Meeting Minutes

Project Name: Wood Residence

Date of Meeting: 6/5/2026

- **Primary Wardrobe** – see attached markups and notes on the shop drawing

- **Servery**

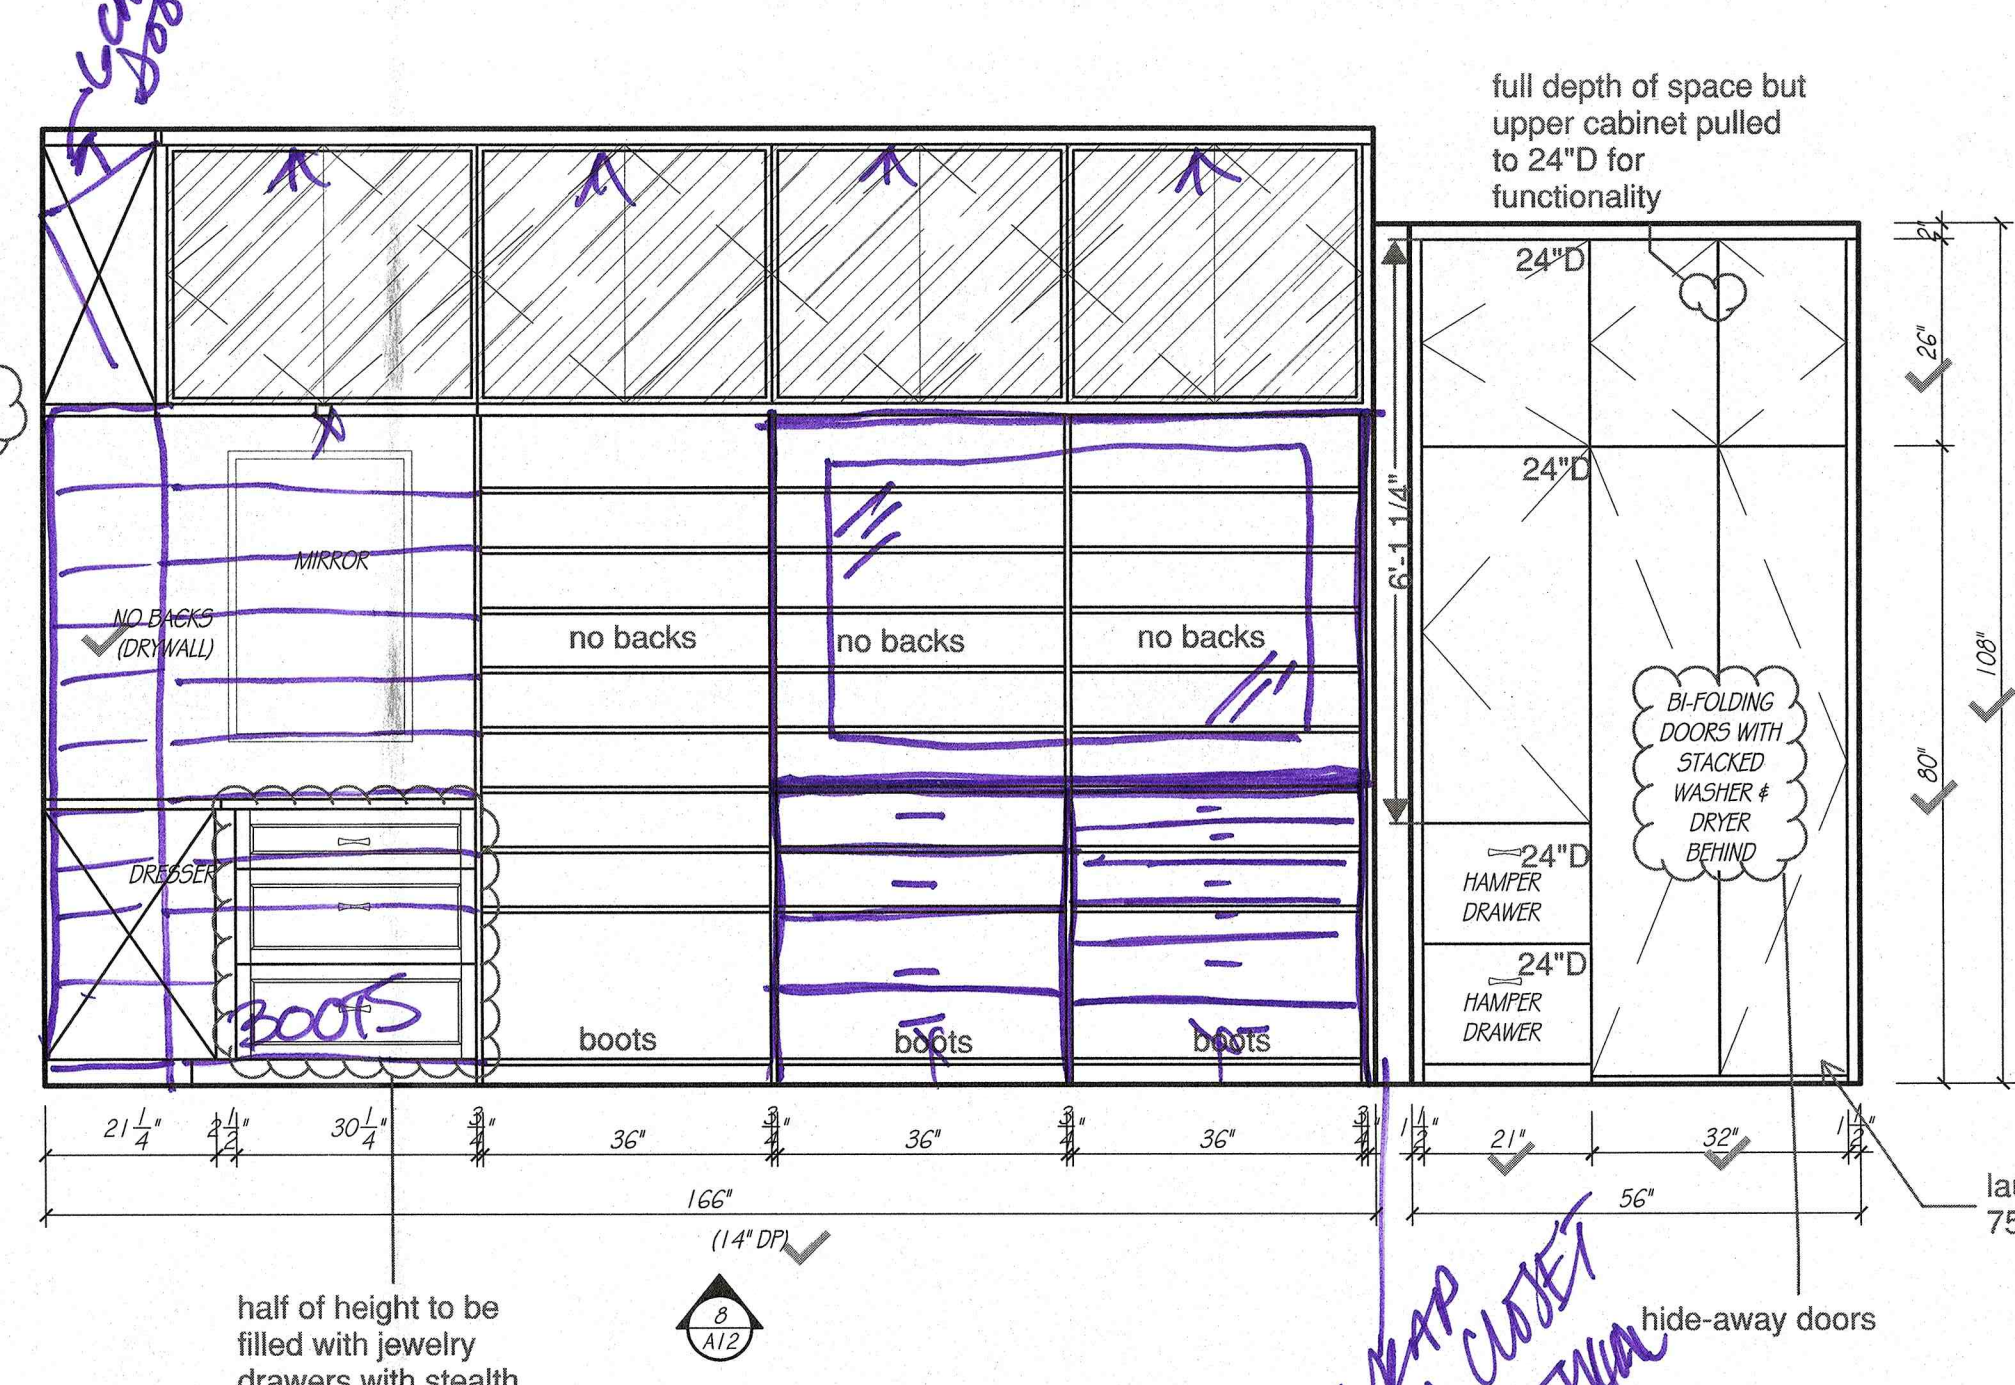
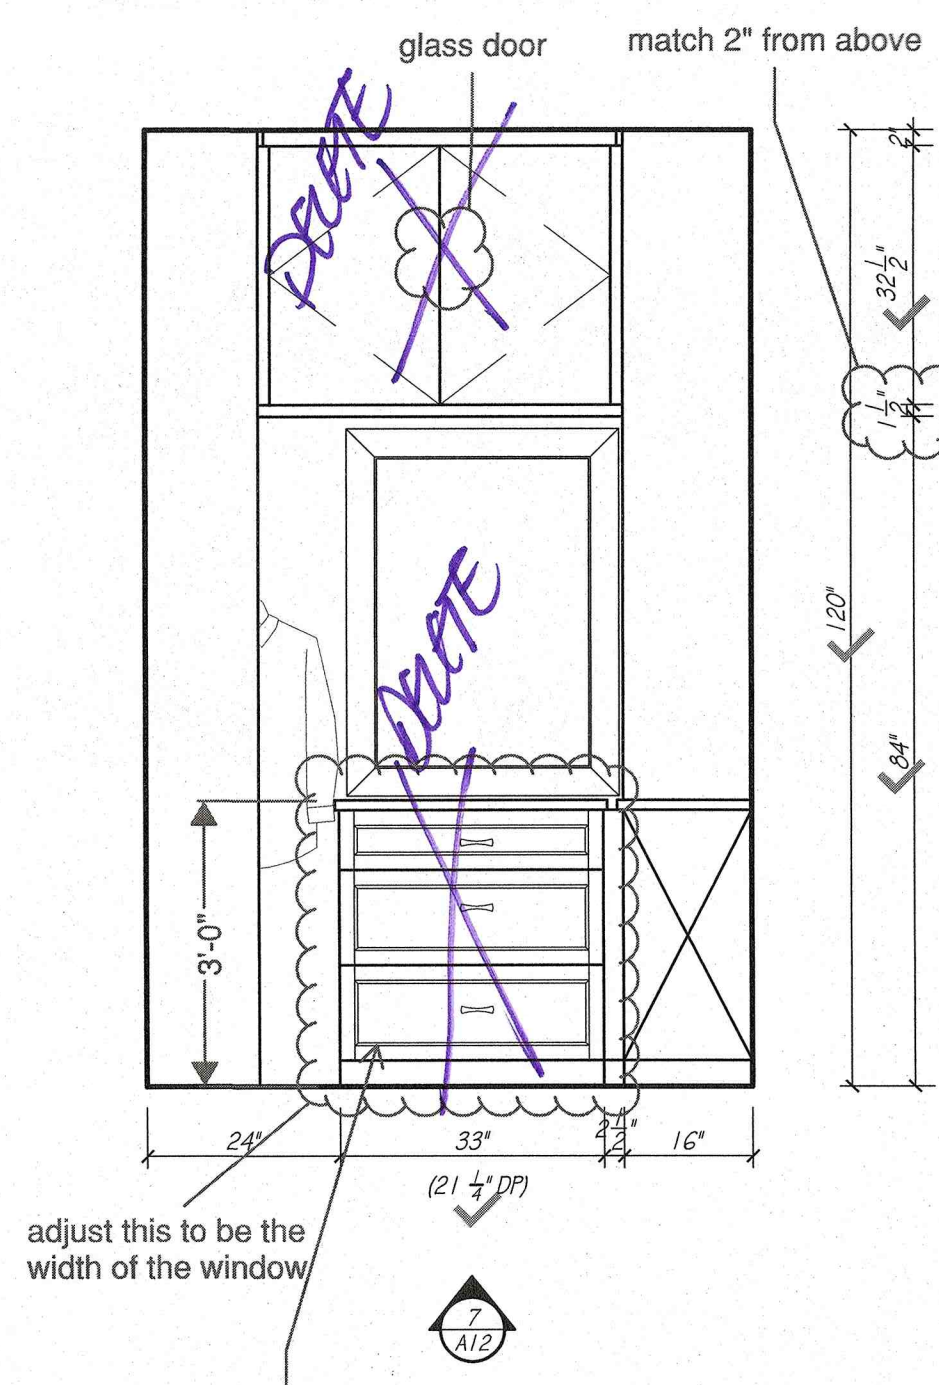
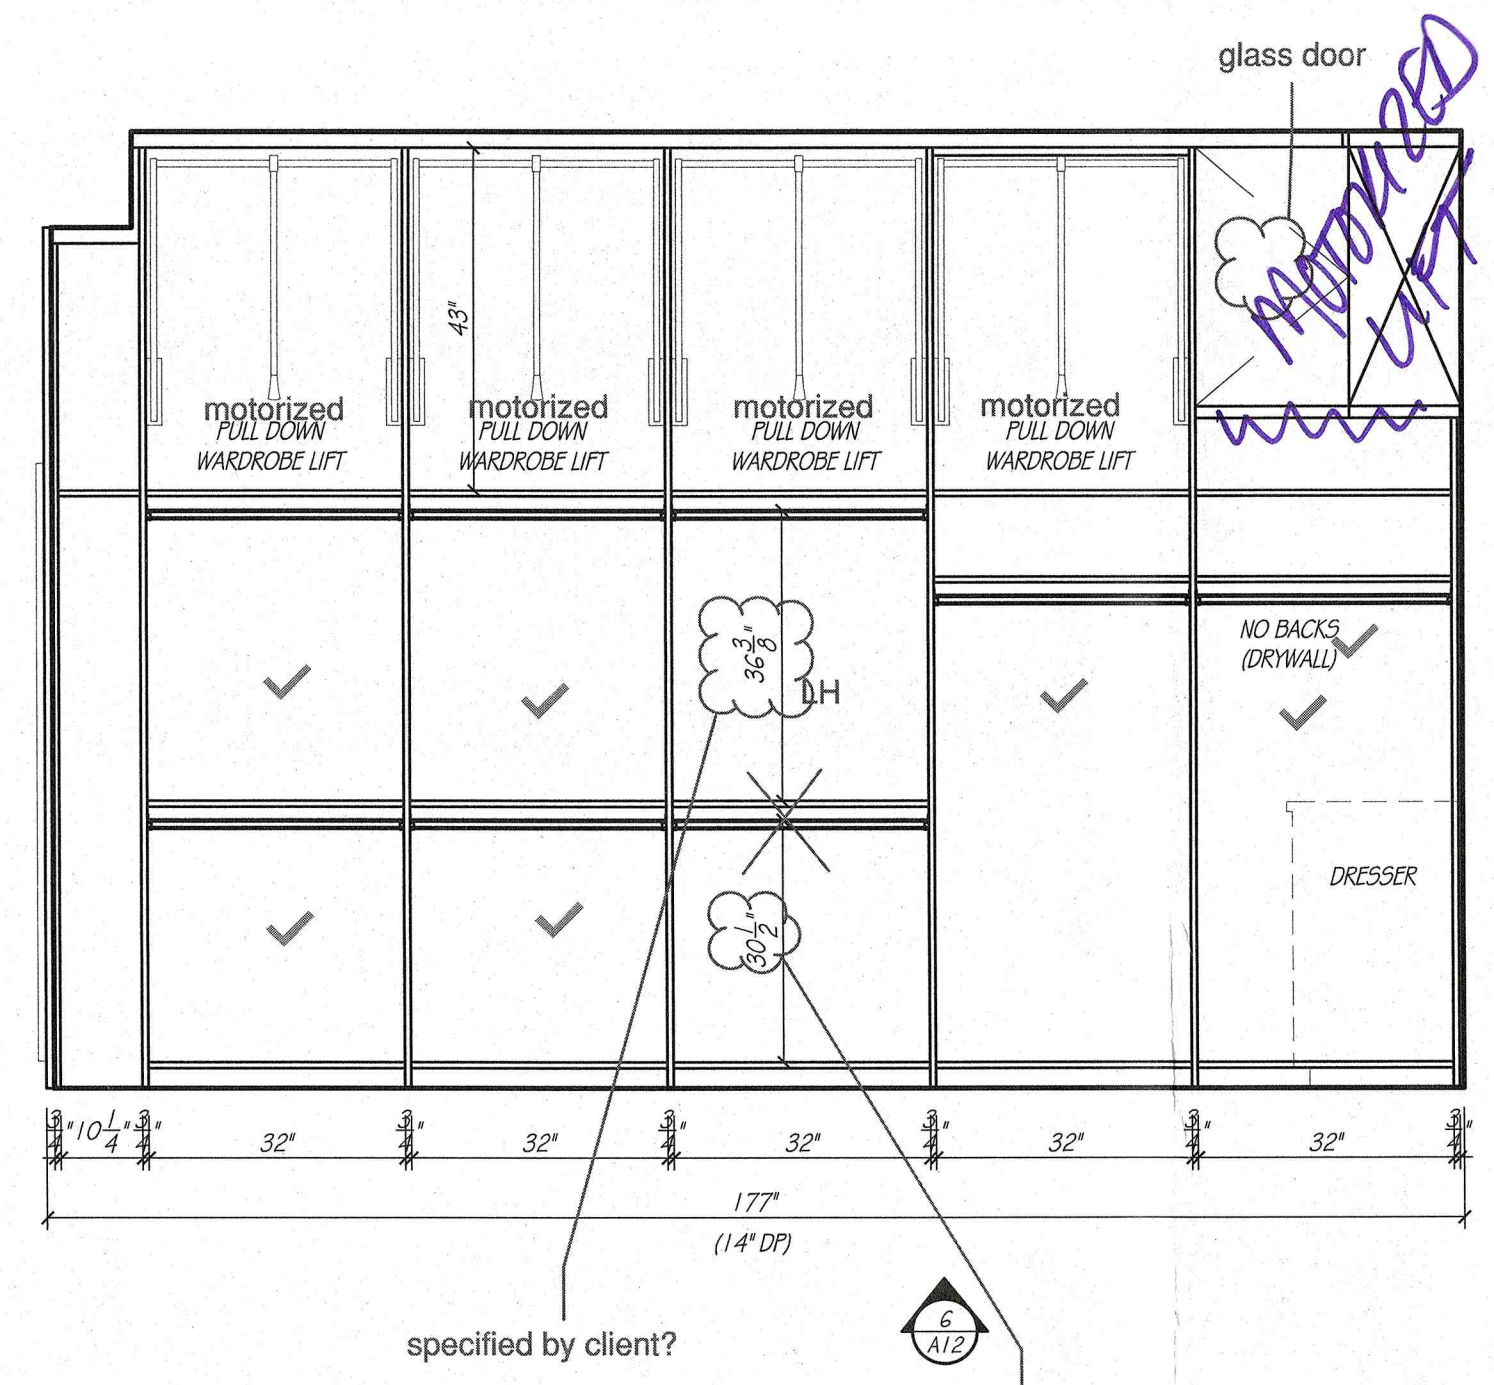
- Change outlets to plugmould at underside of the two uppers – not full length if possible
- Move the keypad over so it doesn't run into the casing
